ORIGINATION FORM

Proposed Revisions to a Standard Plans Index
(Please provide all information — Incomplete forms will be returned)

Index Number: 649-020
Sheet Number (s): 3 of 6
Index Title: STEEL CCTV POLE

STEEL CCTV POLE

SECTION A-A

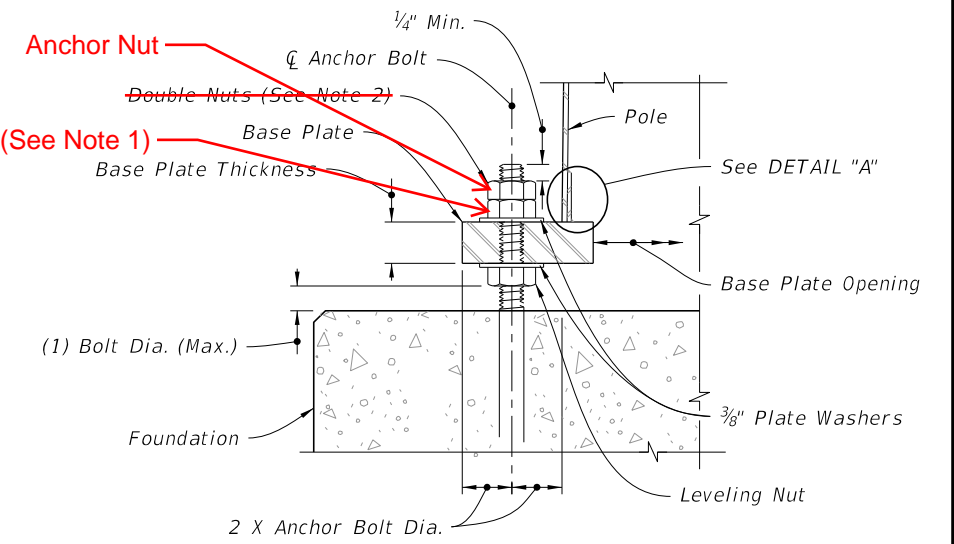
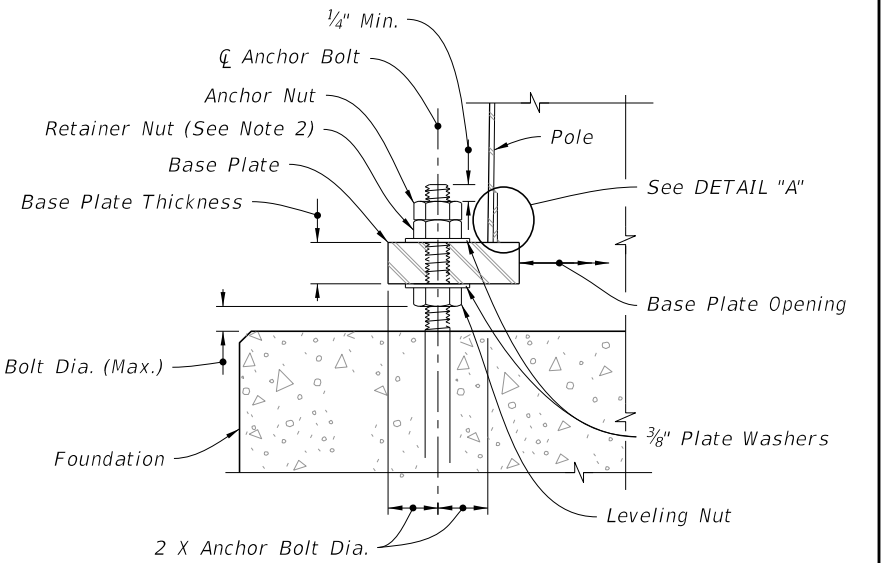
Sheet 3: Changed Note 2 and revised Section A-A to add clarity to anchor bolt nuts.

Sheet 3: These changes were to add clarity, consistency, and specificity to the anchor bolt nuts.

1. Shaft Length is based on 1'-0" height above the finished grade.
2. Retainer nut may be half-height. Provide individual nut covers (not shown) for each bolt.
3. Conduit and CSL Tubes not shown for clarity.
4. Work these details with Data Table on Sheet 2.

SHEET
3 of 6

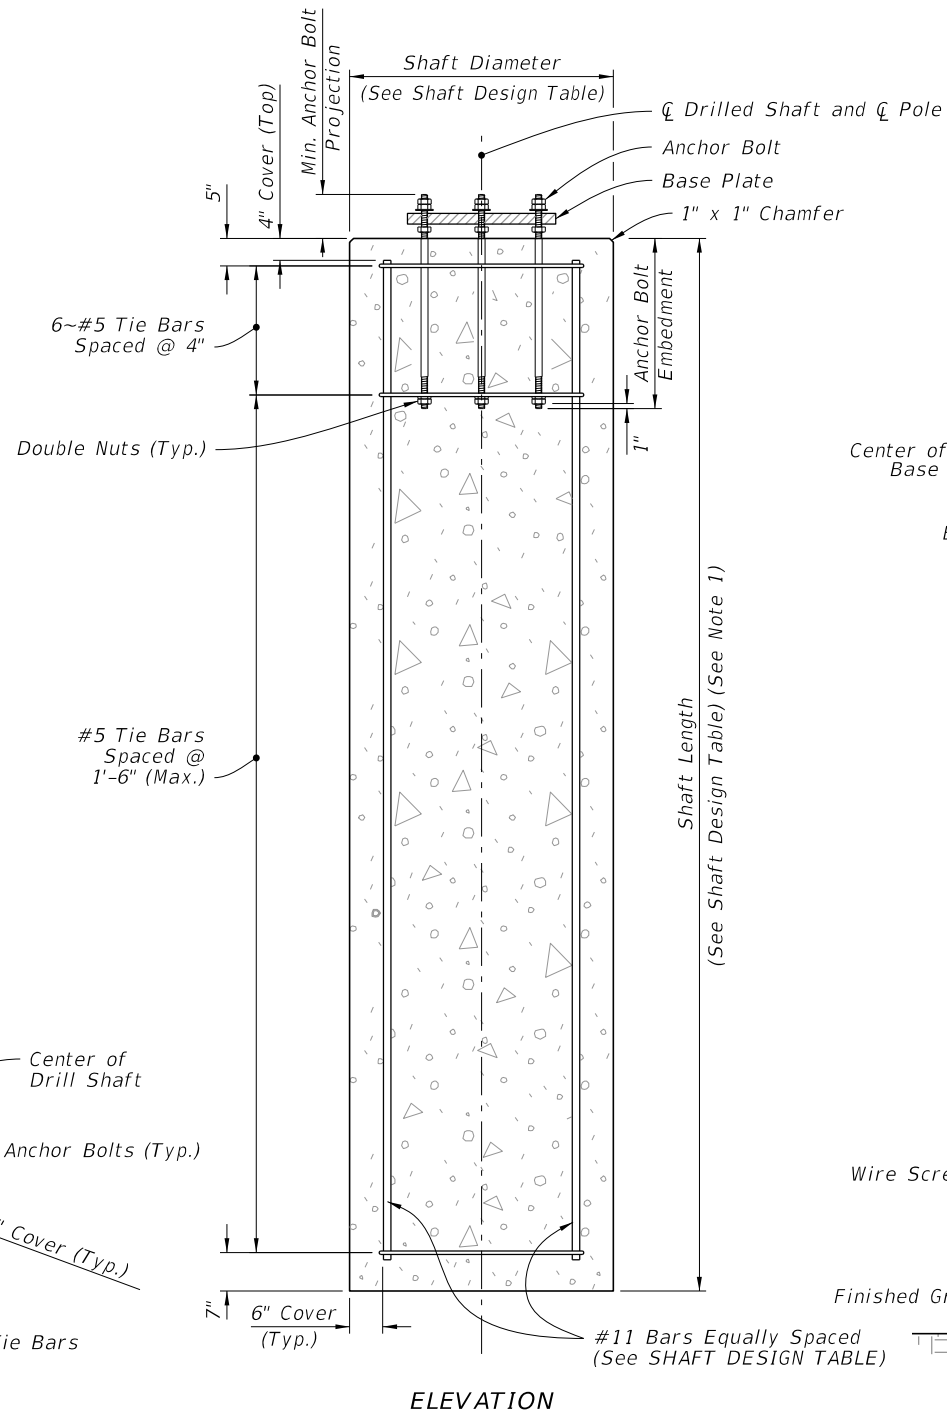
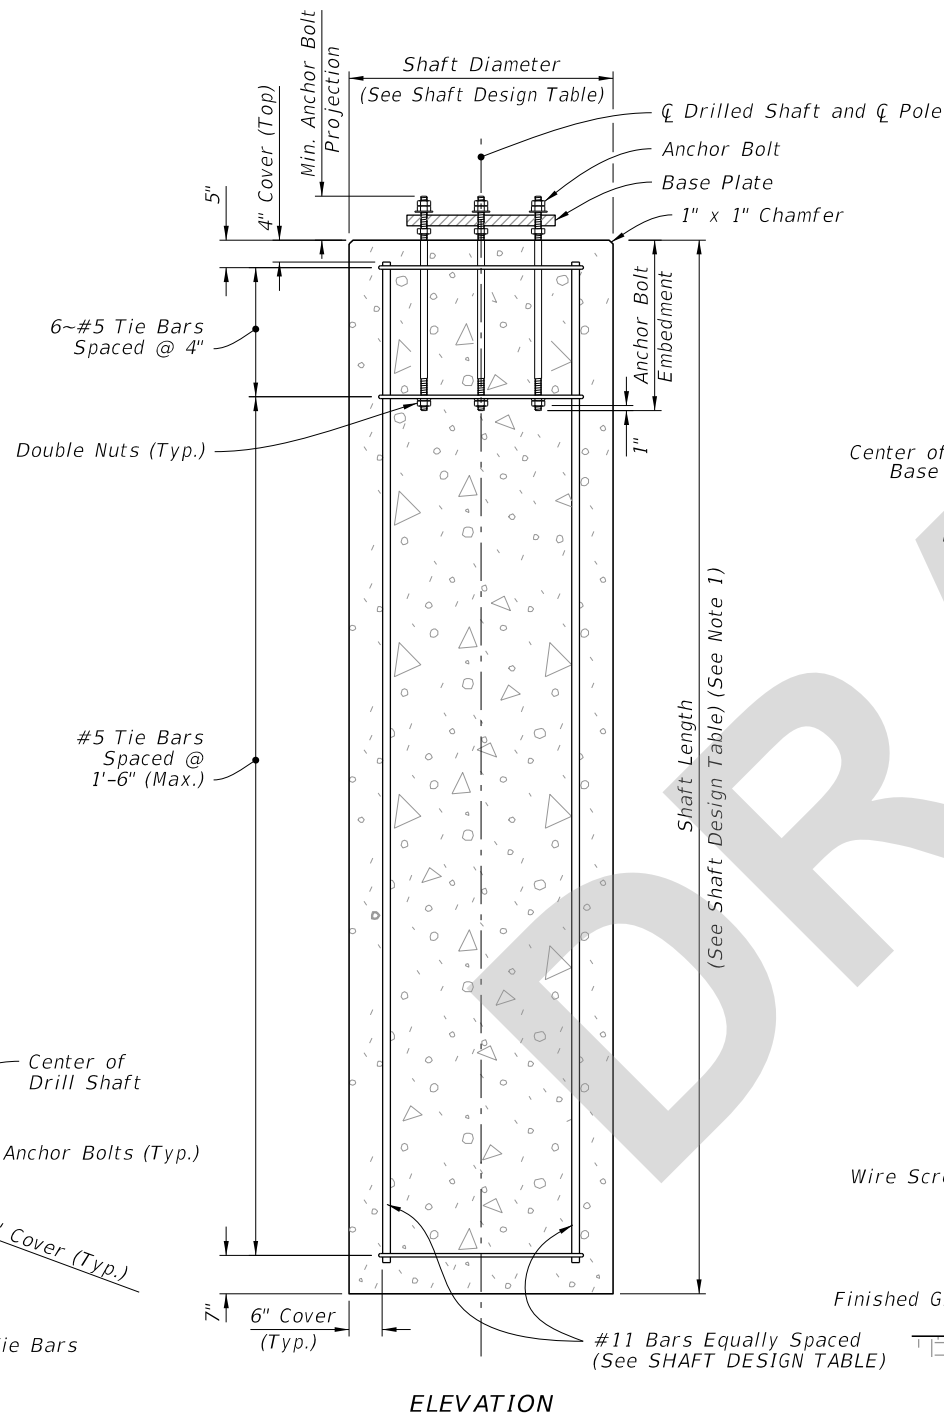
1. Shaft Length is based on 1'-0" height above the finished grade.
2. ~~Double Nuts: Bottom nut may be half-height jam nut. Provide individual nut covers (not shown) for each bolt.~~
3. Conduit and CSL Tubes not shown for clarity.
4. Work these details with Data Table on Sheet 2.
